**TOWN AND COUNTRY PLANNING ACT 1990
APPEAL UNDER SECTION 78**

**APPEAL BY BERKELEY HOMES (OXFORD & CHILTERN) LTD AGAINST THE DECISION
BY READING BOROUGH COUNCIL TO REFUSE PLANNING PERMISSION FOR
Demolition of existing structures and erection of a series of buildings ranging in height
from 1 to 11 storeys, including residential dwellings (C3 use class) and retail
floorspace (A3 use class), together with a new north-south pedestrian link, connecting
Christchurch Bridge to Vastern Road
AT
55 Vastern Road, Reading, RG1 8BU**

**INSPECTORATE REFERENCE: APP/E0345/W/21/3276463
READING BOROUGH COUNCIL REFERENCE: 200188/FUL**

PROOF OF EVIDENCE

Sketch of the locally listed building (not to scale) indicating how design and stylistic elements of the building could and should have been identified and presented in the DAS, in order to inform the design rationale of the redevelopment scheme.

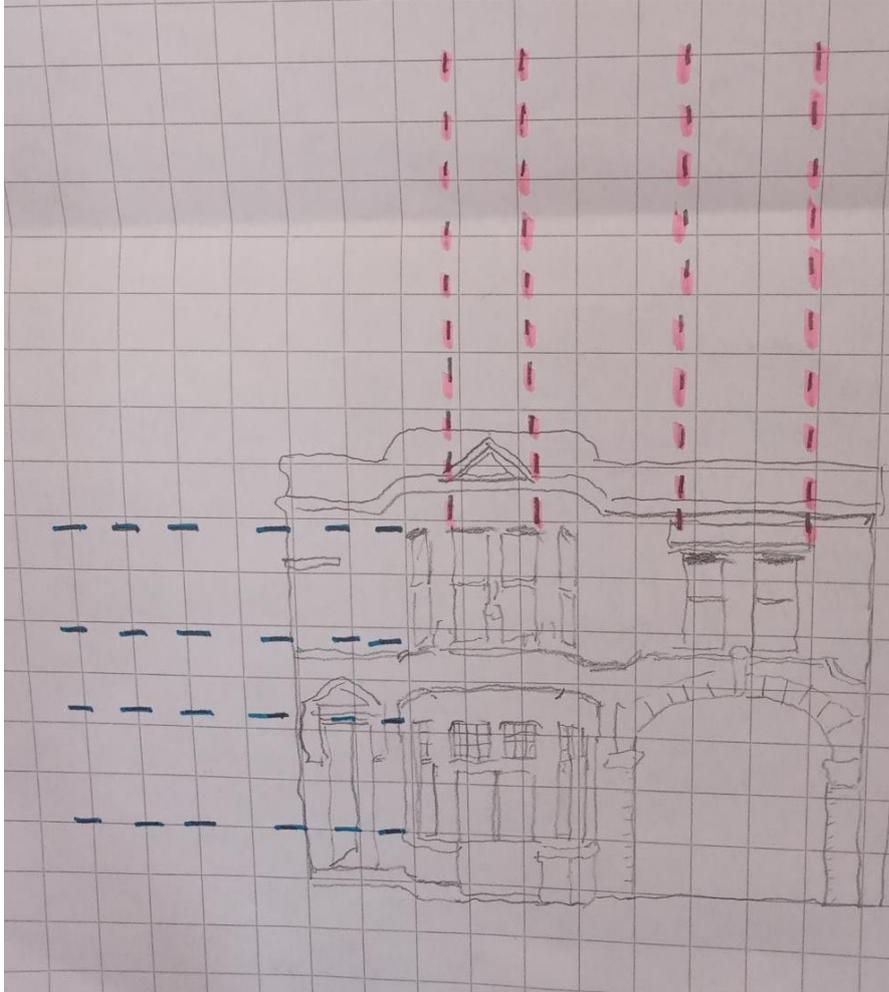
- 2.13 In this situation, the applicant's DAS (page 37 'option studies') cannot be relied on to have accurately picked up the dimensions of the locally listed building and therefore correctly assessed whether it is capable of inclusion within the redevelopment scheme, as there are no indications in the DAS of the redevelopment scheme 'responding' accordingly. Page 37 of the DAS simply shows the NDHA set within or adjacent to a large, blank building envelope. The focus of an initial scoping study should be identifying significant features of the building and a usual starting point would be setting horizontal and vertical planes for the window openings for the adjoining redevelopment scheme. At Appendix 1 I provide a sketch to illustrate this.

- 2.14 Ideally scoping should identify on more than just openings and note the key features of the locally listed building and for those to be used as reference points for the adjacent redevelopment. I would have expected the sections in the DAS to be much more extensive, scalable and accurate, so you could appreciate the detail of the locally listed building and properly work from the design cues. The façade scoping itself would only deal with two dimensions whereas a fuller study would pick up the dimensions of the building in 3D, rather than just 2D.
